UNITED STATES  
NUCLEAR REGULATORY COMMISSION  
WASHINGTON, D. C. 20555

Docket No. 50-70

The attached letters: October 22, 1980 Ellsworth (USGS) to Maxwell (ACRS Consultant) and December 3, 1980 (unsigned response) directly relate to the GETR Show Cause Proceeding and are provided for your information and the public record. The Ellsworth classification, with respect to activity, of the Verona fault is discussed on page 9, Section A of our May 23, 1980 safety evaluation. The reclassification from "probably" active to "possibly" active, as discussed in the attachments, does not alter our conclusions regarding the proper seismic design bases for the GETR.

G E T R

Figure 9

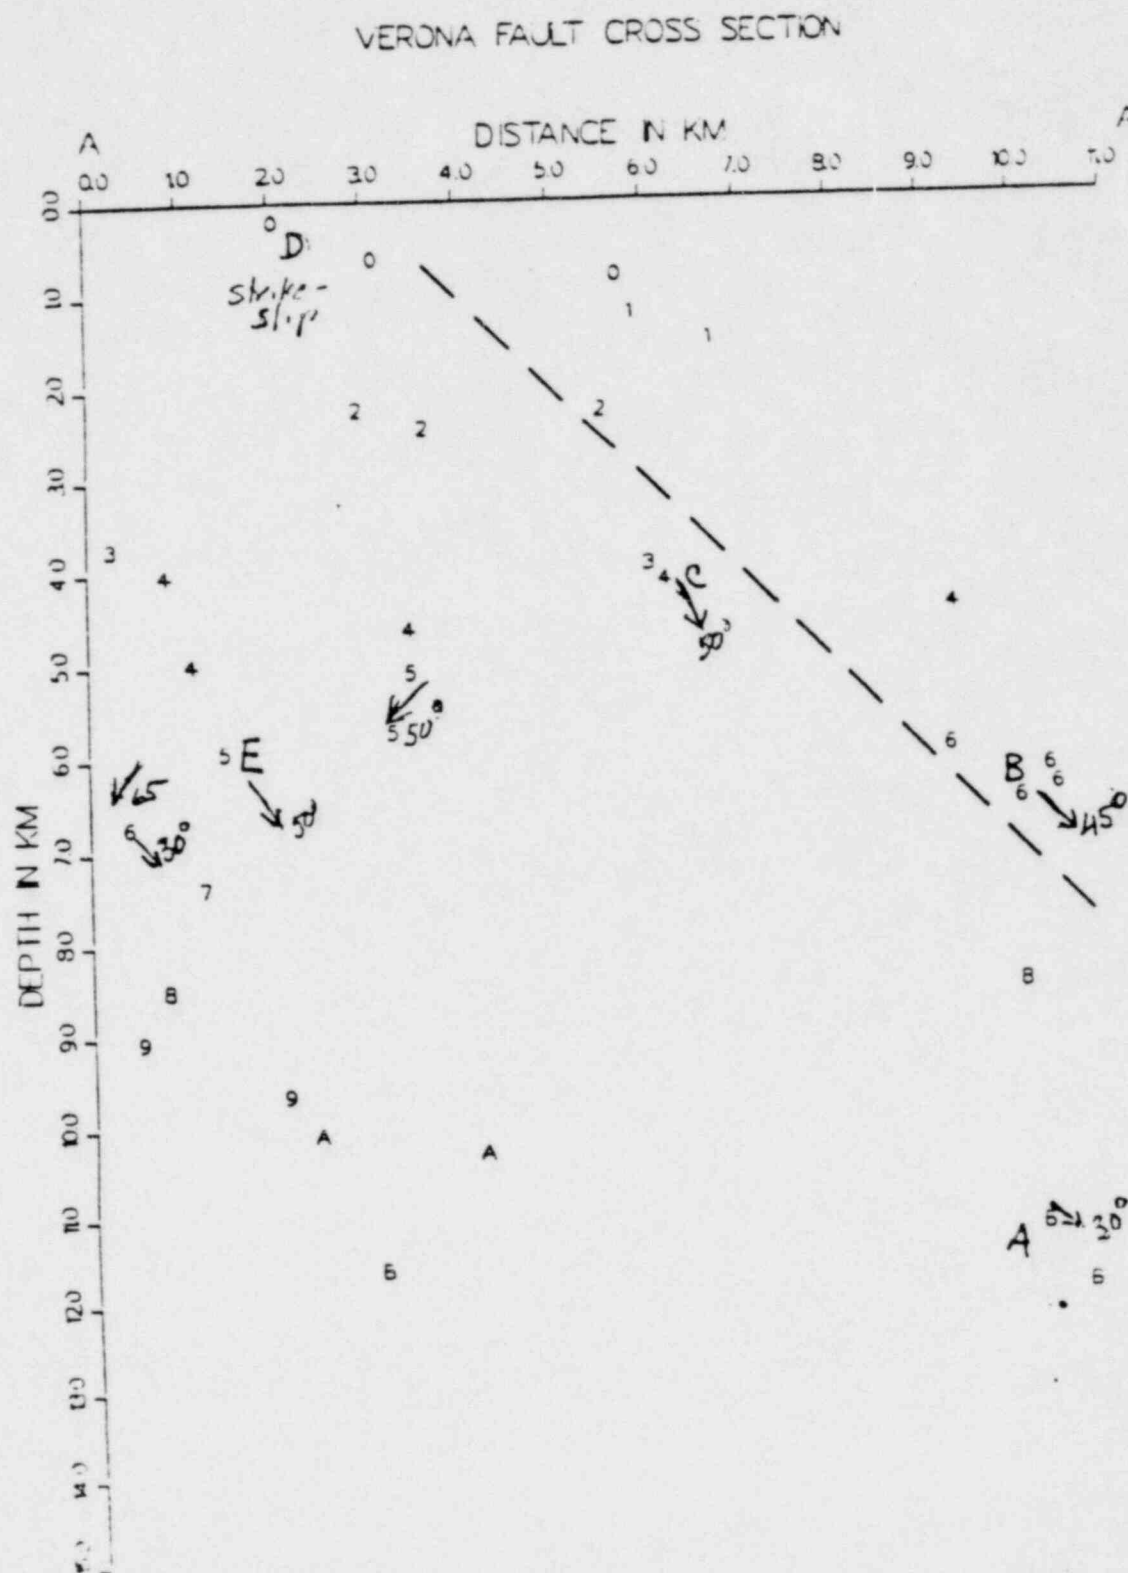
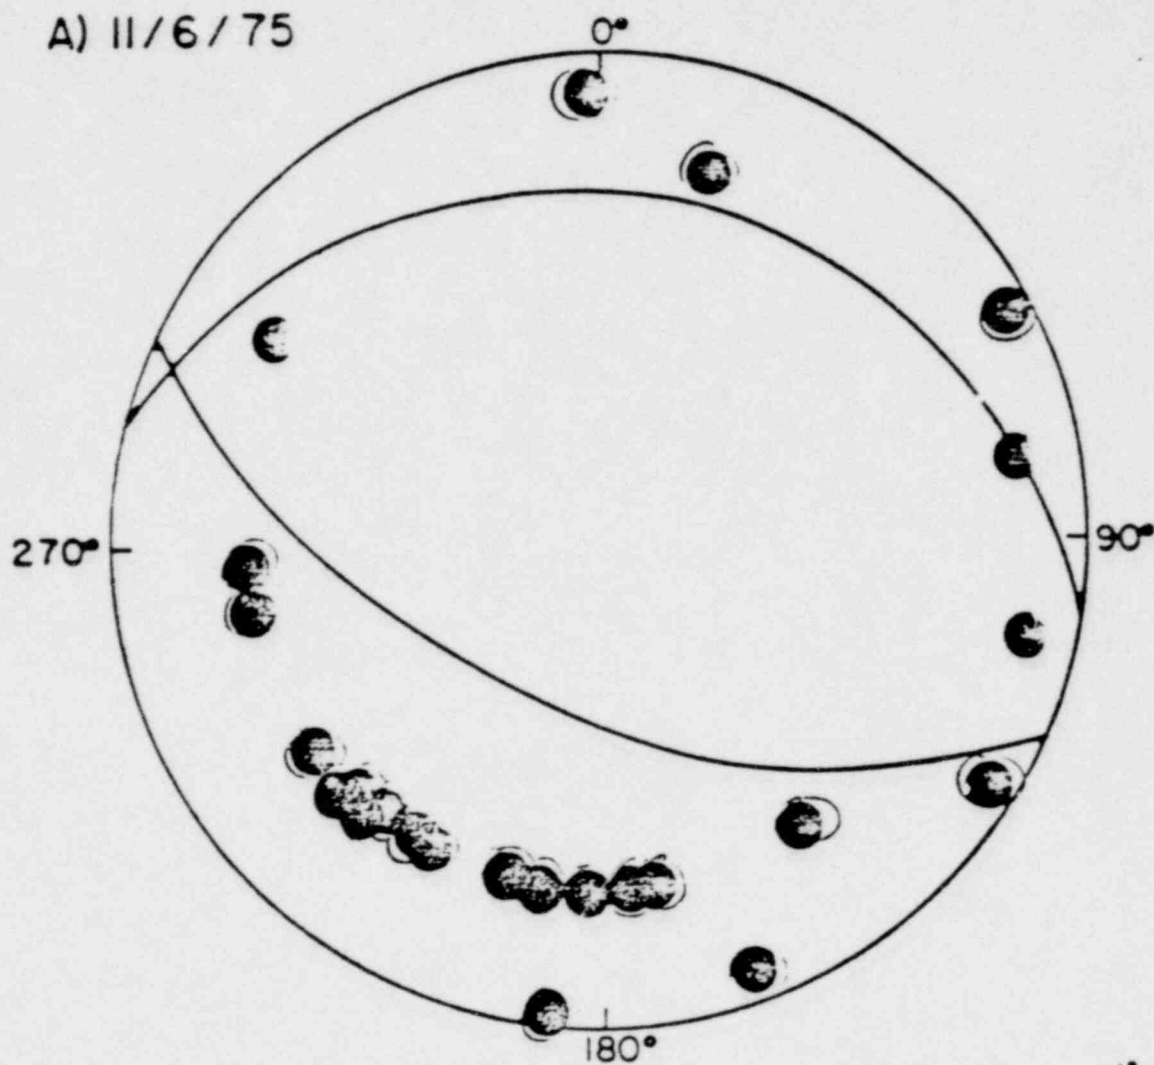
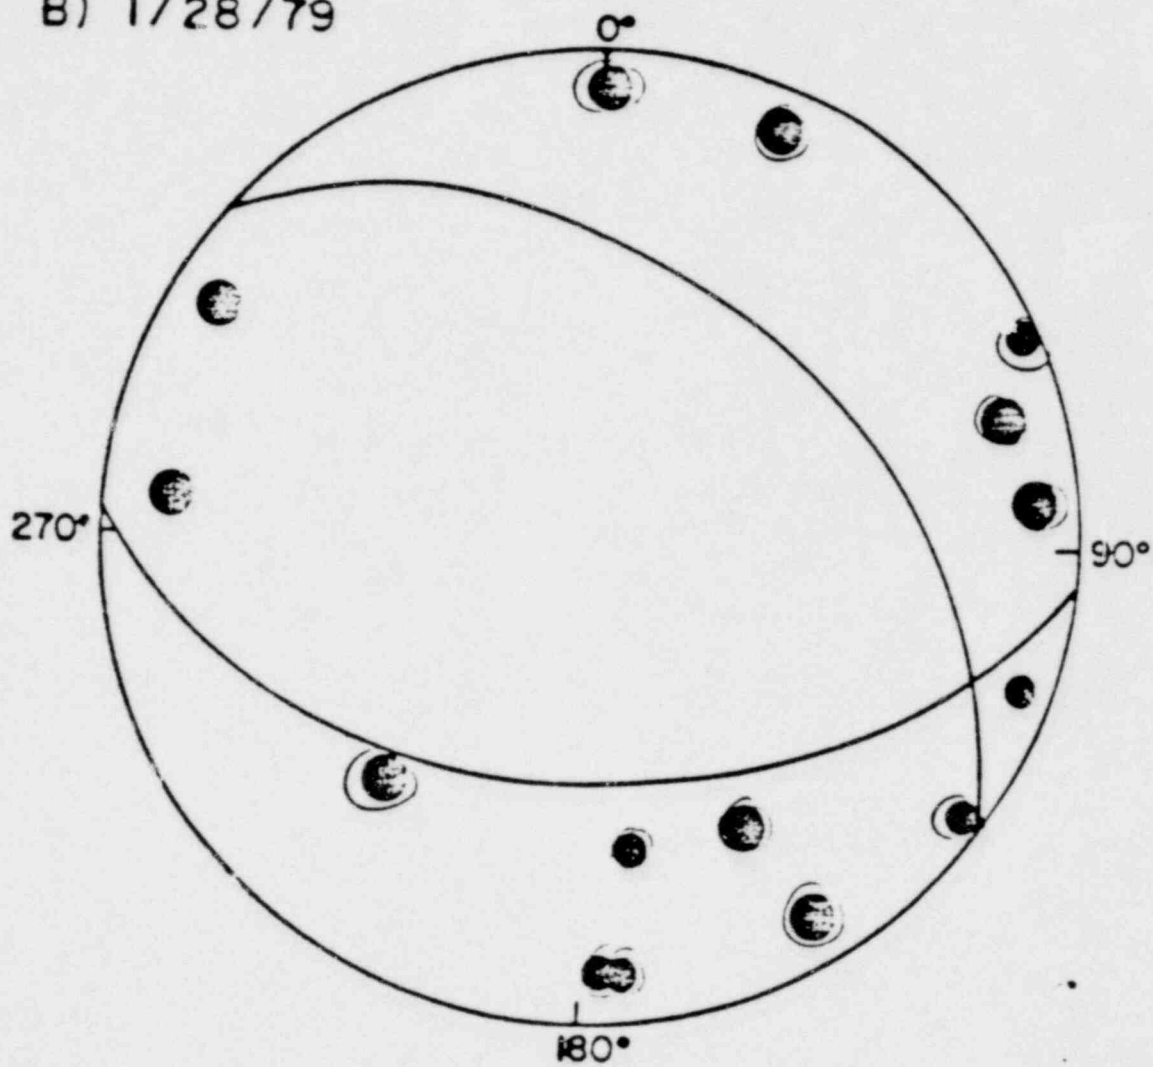
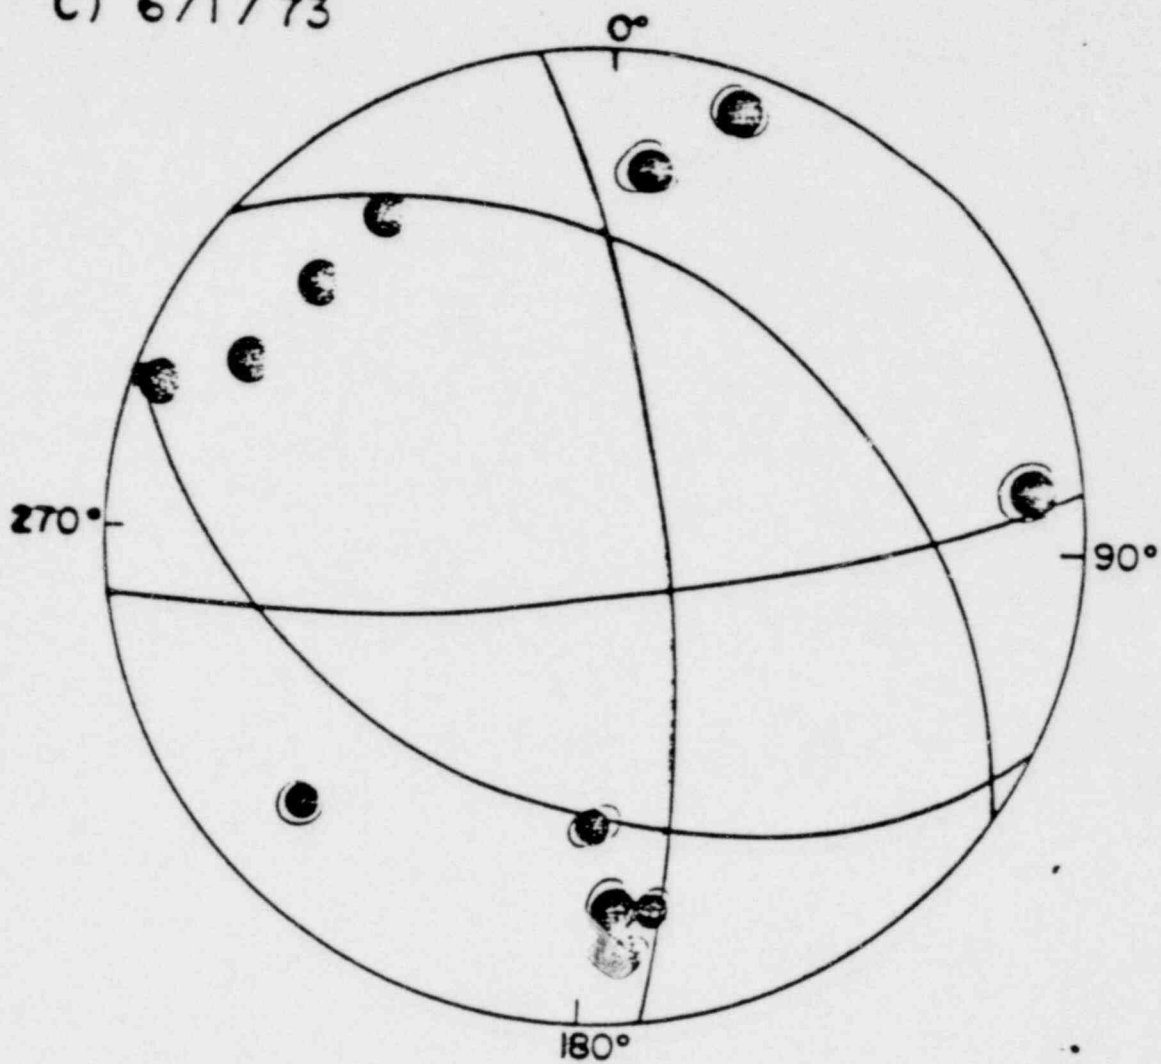
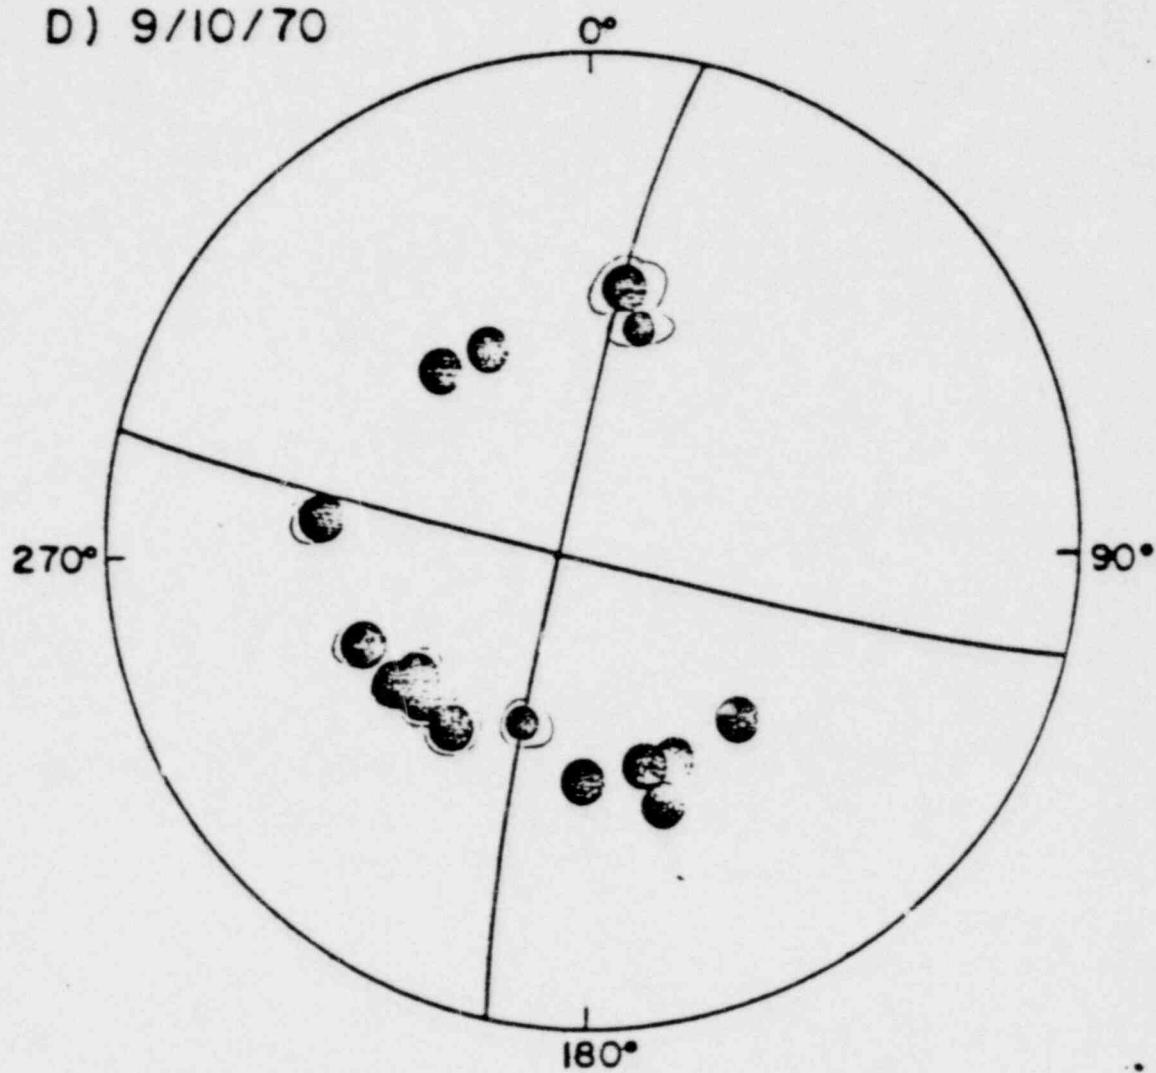
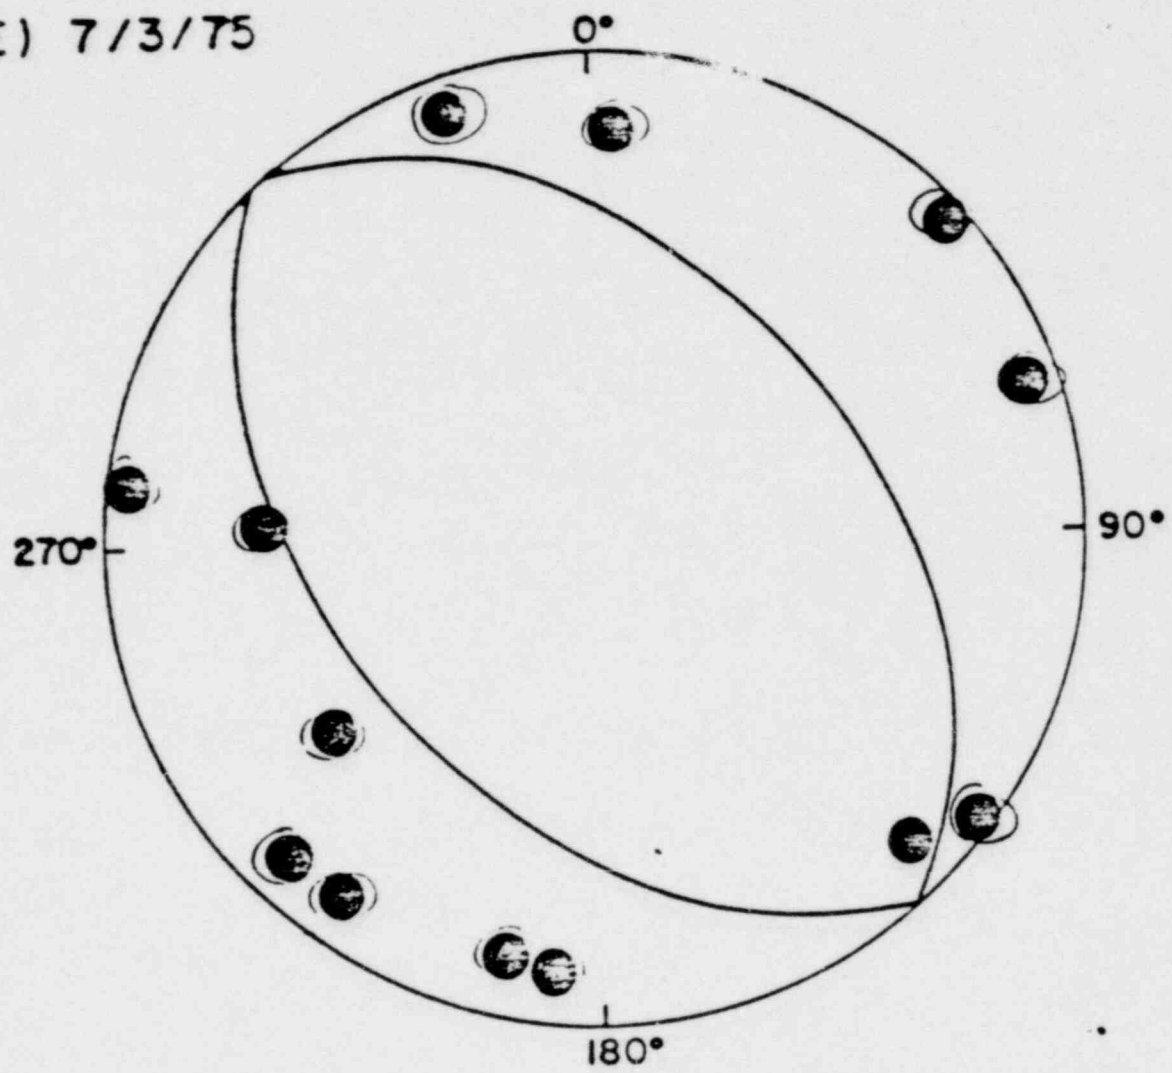
One difference that should be noted, and which has some impact on my earlier evaluation of the Verona fault comes from our re-interpretation of the original seismograms for events 6 and 17 in the attached sheets. We now find that either strike slip or thrust fault plane solutions fit the observations. This weakens the case for the identification of the Verona as a "probably" active fault on the basis of seismological evidence. However, the evidence is still permissive and other focal mechanisms indicate compressive tectonics. I would now classify the Verona fault as "possibly" active, based on the microearthquakes and criteria defined in Open-File report 80-515. In view of the fact that the same criteria and data set classified the Greenville fault as possibly active prior to the January 1980 earthquakes, I find little comfort in the revised classification for the Verona fault.
